CITY OF PORTERVILLE
CALIFORNIA
ANIMAL SHELTER PROJECT
PROJECT NO: 89-9015-88
BID NO: 21/22-CP1918 (Rebid)

BEGINNING OF ADDENDUM No. 3

Date: August 11, 2022

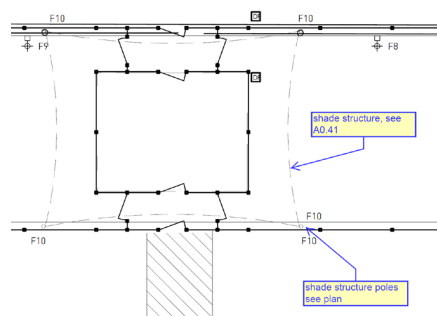
1. Please verify if specification section 035400 Cementitious Underlayment (self-leveling floor underlayment) is required for the entire concrete slab or please verify what locations this will be required.

This Section is referenced in Section 096700 Fluid-applied Flooring which is the Epoxy Flooring.

Finish plans Indicate that "ALL FLOORS WITH DRAINS SHOULD BE SLOPED TO DRAIN @ 1/8" PER 1'-0"."

The cementitious Underlayment is to be used to achieve this slope to drain requirement.

(NOTE that all existing flooring and all existing ceilings are to be demolished. All glue and debris shall be removed so that flooring can receive new finish as indicated on the Finish plan.)
